Certified model	Additional models	
MRG-B1000	MTG-B1000	OCW-S4000

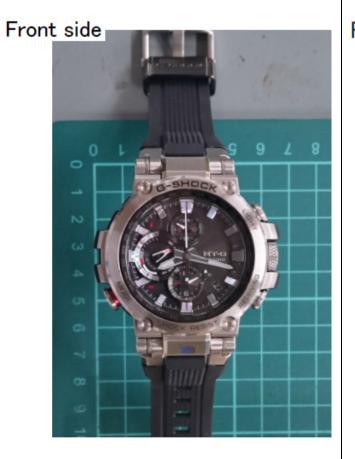
No changes have been made to the radio specification from the certified model. The only differences between the additional models and the certified model are design of watch face (display) and design of enclosure. However, as a result of preliminary confirmation, degradation exceeding 3 dB in the spurious emissions test was observed for both MTG-B1000 and OCW-S4000 compared to the certified model. Therefore we request a Class II permissive change.
